**High Speed Craft Consultative Committee (HSCCC)**

**Proposed Changes of Navigation Aids for Marking Adamasta Rock**

**Diagram 2 : Proposed Navigational Aids for Marking Adamasta Rock**

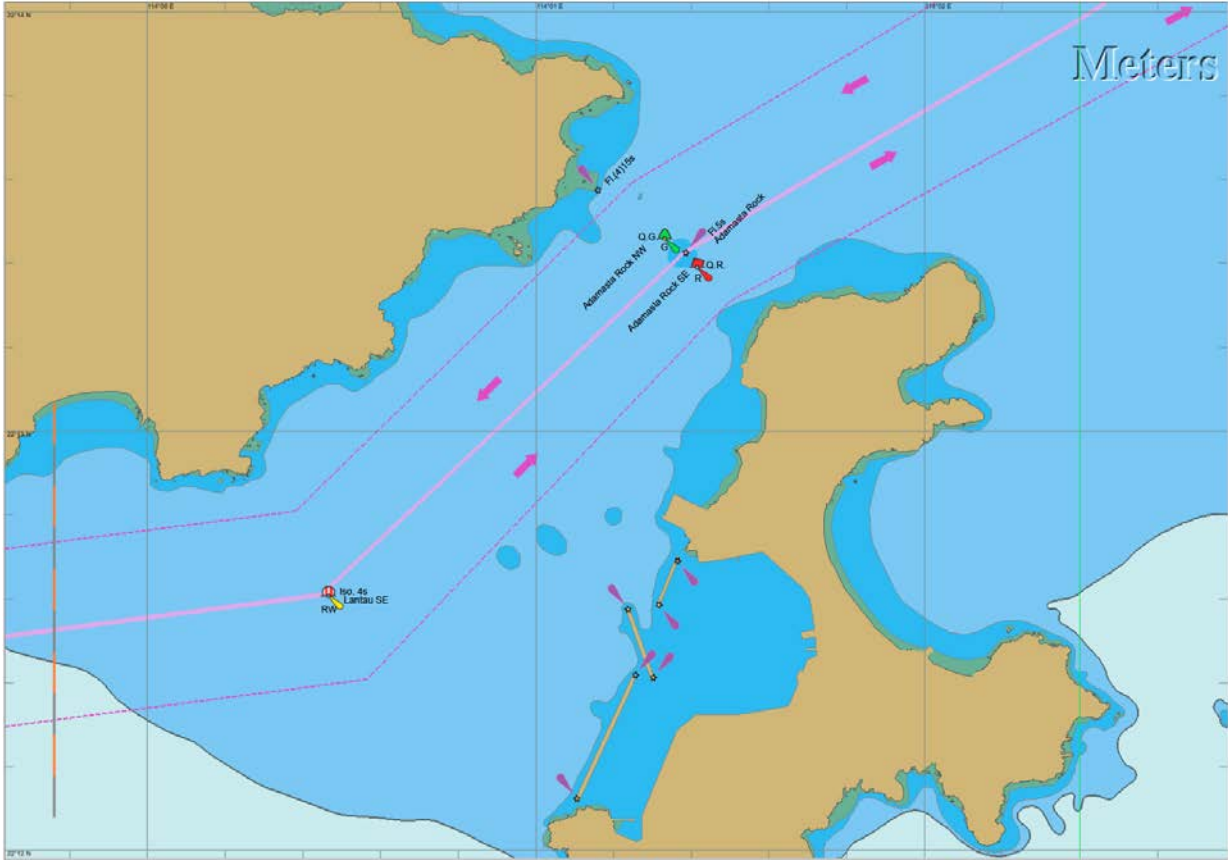
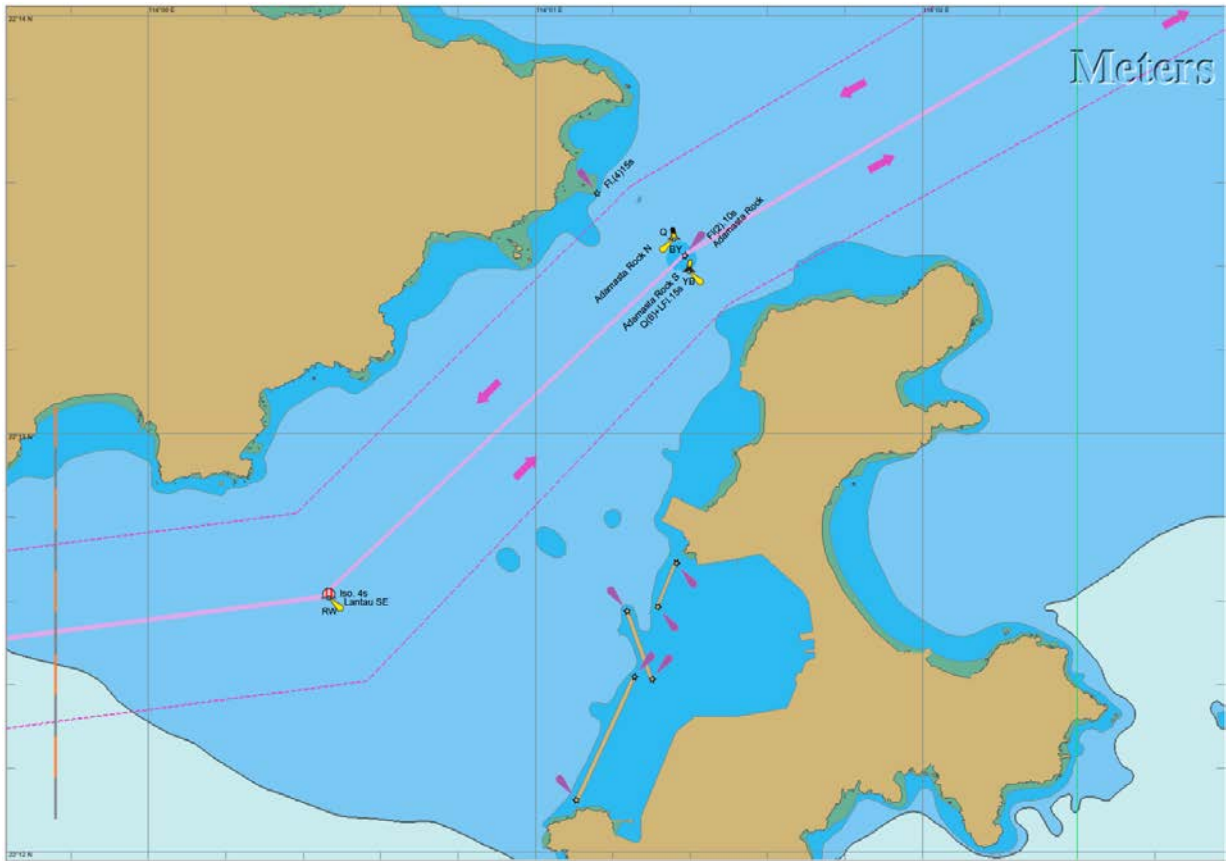
- (i) replacing two existing lateral buoys, currently marking the boundaries of the shoal around Adamasta Rock, by two cardinal buoys at nearby locations (i.e. the northern and southern extremities of the Adamasta Rock shoal) as shown in Diagram 2 below; and
- (ii) changing the light character of the beacon at Adamasta Rock from "Single-flashing" to "Group-flashing (2)", and painting the beacon with black and red horizontal bands.

3. An internal review on the existing navigational aids was conducted for identifying improvements to navigational safety around Adamasta Rock. It is noted that the green conical shape buoy and the red can shape buoy are presented as a pair of lateral buoys laid at the extremities of the Adamasta Rock shoal of about 200 metres apart. As there is a perception that a pair of lateral marks, i.e. the green and red buoys, are laid to mark the two

sides of a waterway, mariners who are not familiar with the Conventional Direction of Buoyage at the Adamasta Channel may consider to travel between the two buoys, in case that they are also not aware of the existence / meaning of the light beacon at Adamasta Rock.

5. Taking consideration of the above findings, the review proposed to replace the existing two lateral buoys by two cardinal buoys<sup>2</sup> at nearby locations, i.e. a cardinal buoy with northern top mark at position of Latitude 22° 13.47' North, Longitude 114° 01.36' East (in WGS 84 Datum) and a cardinal buoy with southern top mark at position of Latitude 22° 13.38' North, Longitude 114° 01.39' East (in WGS 84 Datum), where are the northern and southern extremities of the Adamasta Rock shoal. The light characters of the proposed northern and southern cardinal buoys are "Quick-flashing" and "Quick-flashing (6) followed by a long-flash" respectively. Given the distance between these two buoys is about 200 metres apart, it is also proposed to indicate more clearly the isolated danger characteristic of the beacon at Adamasta Rock by changing the light character of the beacon to "Group-flashing (2)", and painting the beacon with black and red horizontal bands. The proposed navigational aids for marking Adamasta rock are shown in Diagram 2 below.
